Access Compliance Report Public Rights-of-Way (Pedestrian Signals)

Main Street: LOS PATRONES PKWY Cross Street: OSO PKWY Location: SW

ADA ID: SGRK211021114056 Signal Type: One Push Button-APS Overall Compliance: No Severity Scores: BTN 1: 25 BTN 2: N/A No BTN: N/A

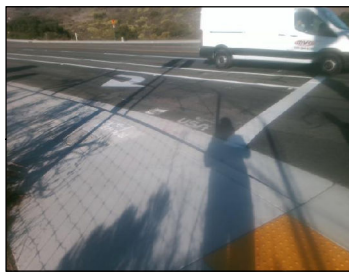
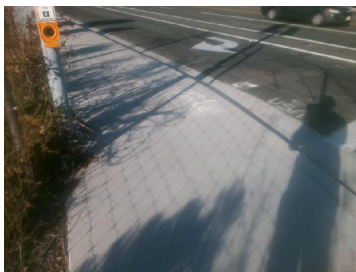
Yes B 1 Closed Fist Operation?		Yes	N/A	B 2 Closed Fist Operation?	N/A
Yes B 1 Diameter (in)		2	N/A	B 2 Diameter (in)	N/A
N/A B 1 Crossing Direction		N	N/A	B 2 Crossing Direction	N/A
Yes B 1 DistanceTo XWalk (in)		48	N/A	B 2 DistanceTo XWalk (in)	N/A
No B 1 DistanceTo Curb (in)		80	N/A	B 2 DistanceTo Curb (in)	N/A
Parcel Identification Number		125-361-09			
Google Street View Link

Possible Solutions: Replace Signal Push Button With APS Button. Remove & Relocate Sign.

OC Std/PROW: MUTCD 4e.08, R404.2
